**BEFORE
THE OHIO POWER SITING BOARD**

In the Matter of the Application of)	
Kingwood Solar I LLC for a Certificate)	Case No. 21-0117-EL-BGN
of Environmental Compatibility and)	
Public Need)

**KINGWOOD SOLAR'S JUNE 1, 2021 RESPONSES
TO STAFF'S MAY 17 AND MAY 20 DATA REQUESTS**

Figure 03-3
Project Layout
Sheet 2 of 3
Kingwood Solar
Greene County, Ohio

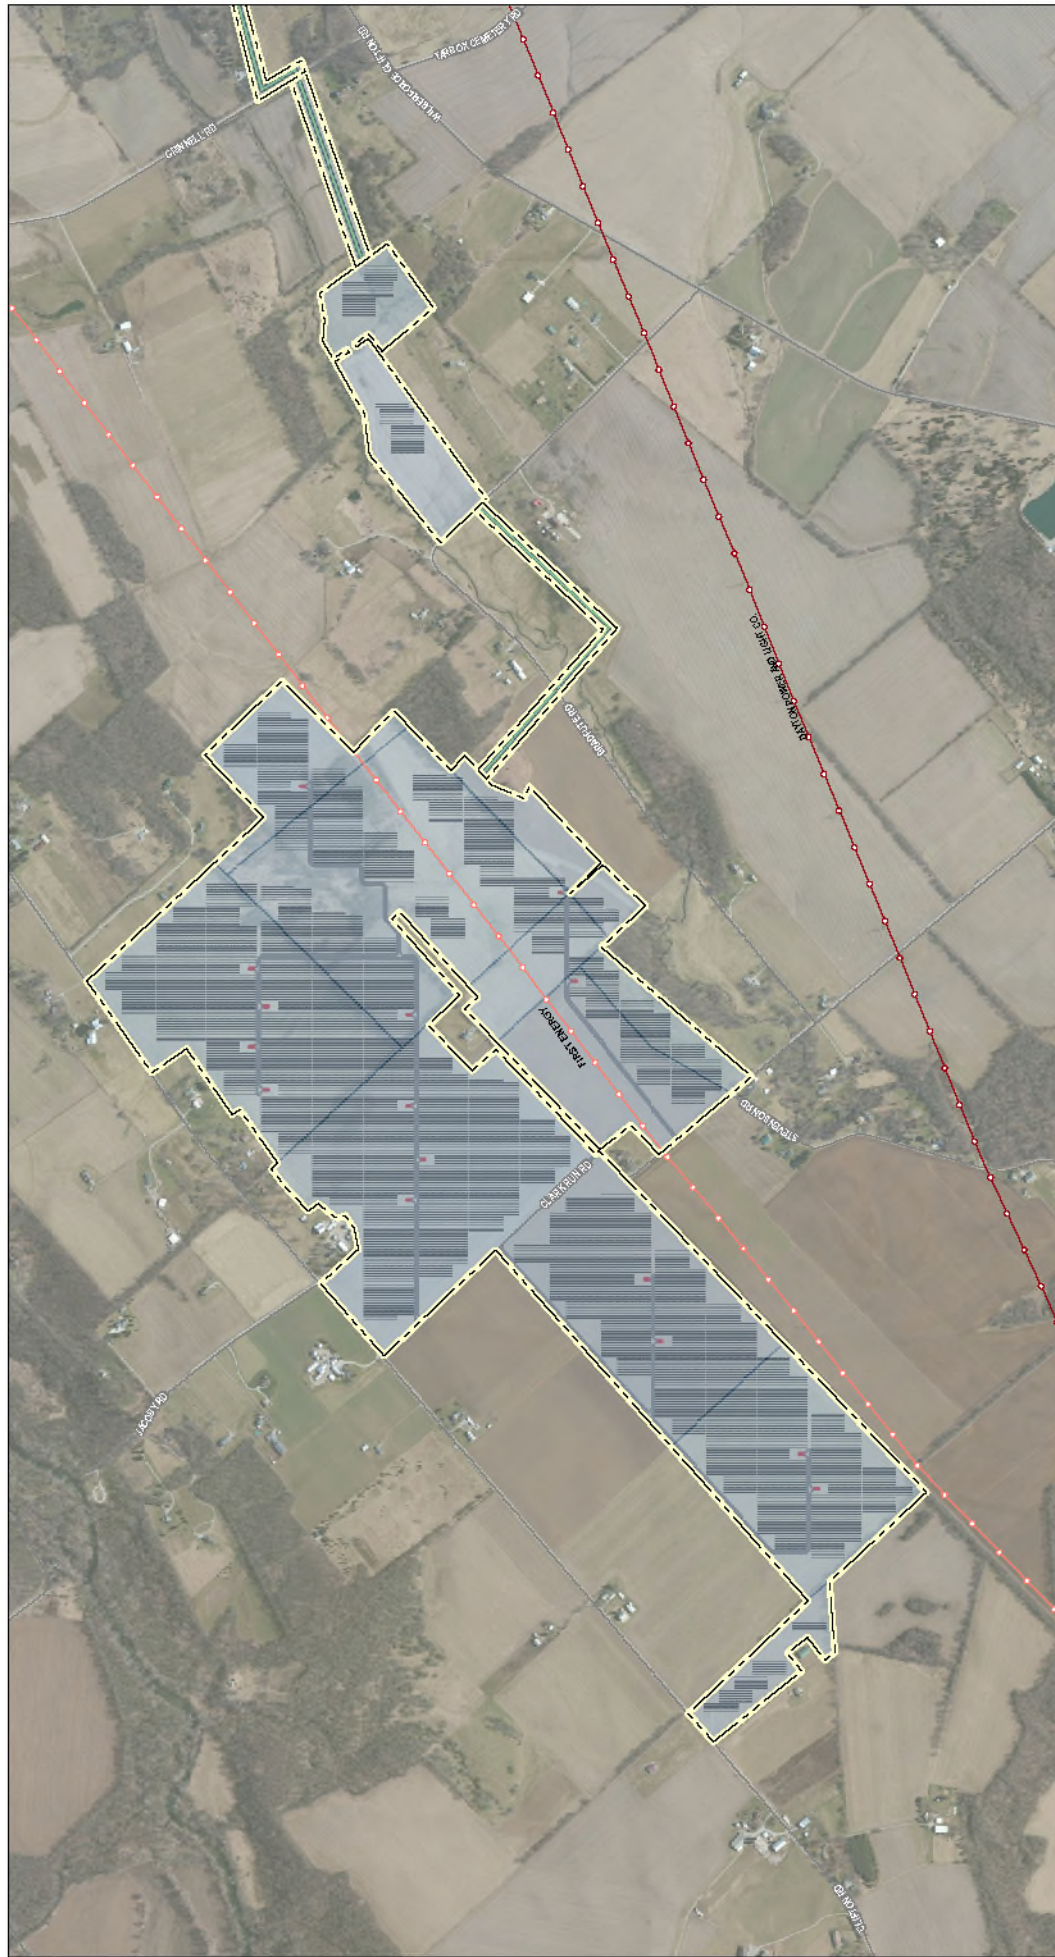
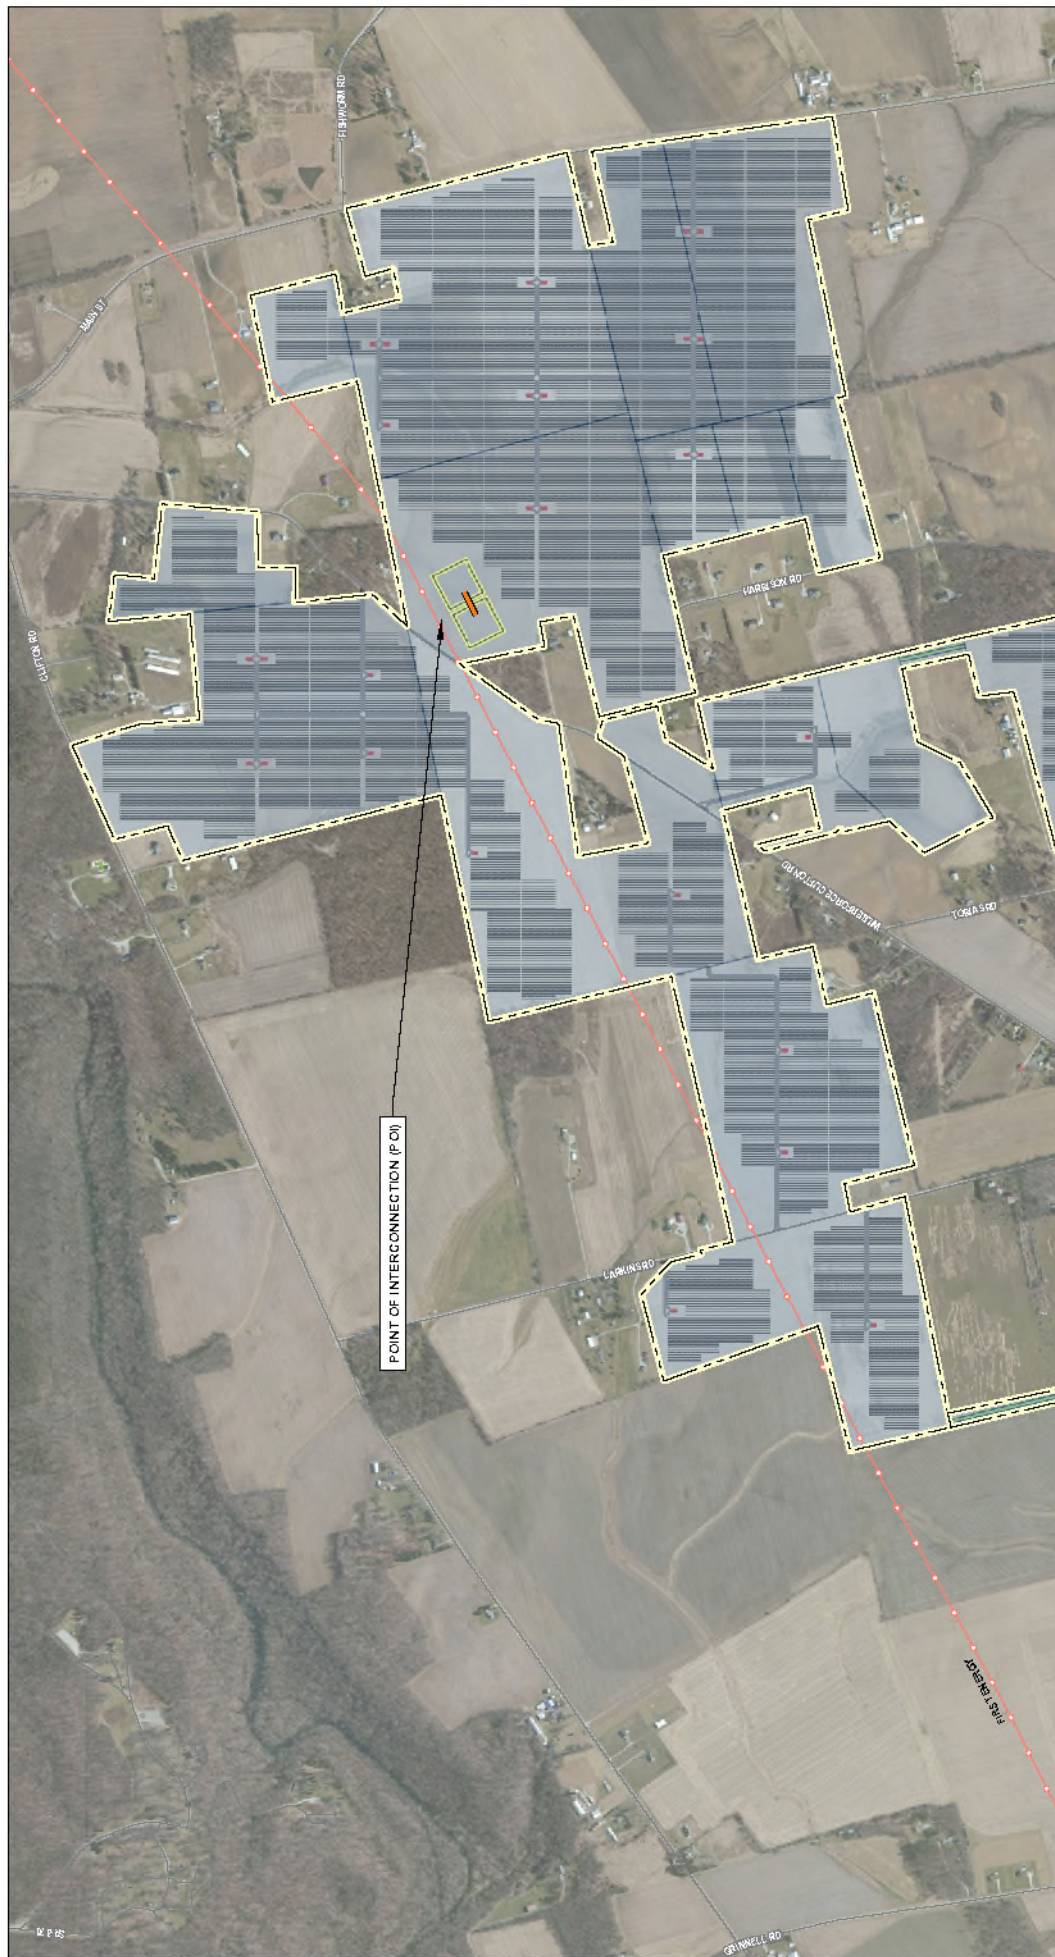
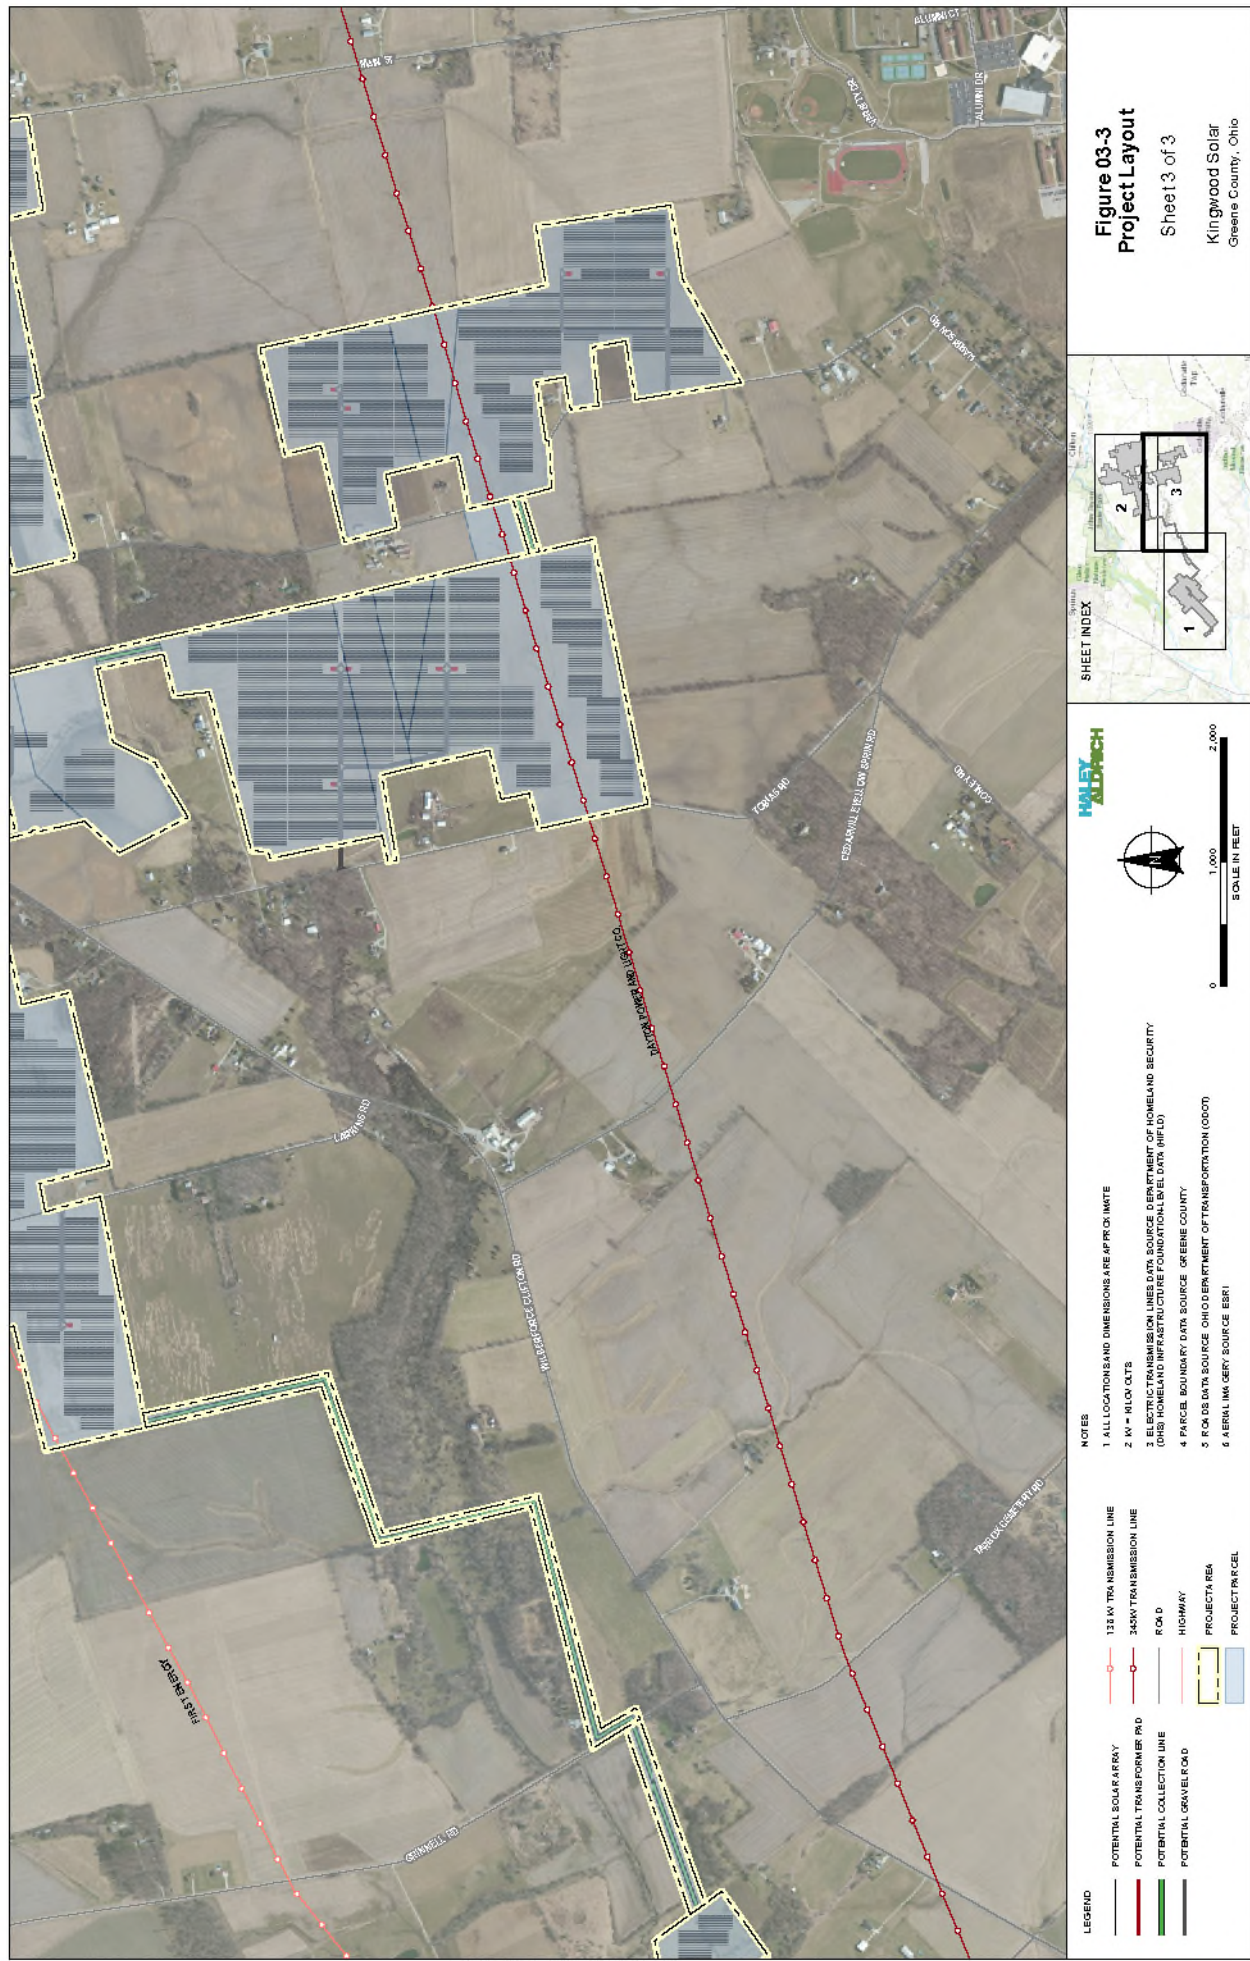
- 20. Please update Figure 03-3 (Project Layout) and other relevant facility mapping to reflect the proposed location of the gen-tie line referenced on page 1 of the Application and provide associated shapefiles.**

15. In follow up to Kingwood Solar's June 1, 2021 Responses to Staff's May 17 and May 20 Data Requests (DR#20) which included an updated Figure 03-3, the included Figure 03-3 doesn't depict the 200 feet of 138 kV gen-tie line but only a POI. Please provide an updated Figure 03-3 (Project Layout) and other relevant facility mapping that depicts the specific proposed location of the gen-tie line referenced on page 1 of the Application and provide associated shapefiles.

An updated Figure 03-3 is attached. The associated shapefiles will be provided separately to OPSB Staff.

An updated version of Figure 03-3 is provided depicting the approximate location of the 200-foot 138-kV gen-tie mentioned on page 1 of the Application. This location may shift slightly depending on the final design of the interconnection facilities.
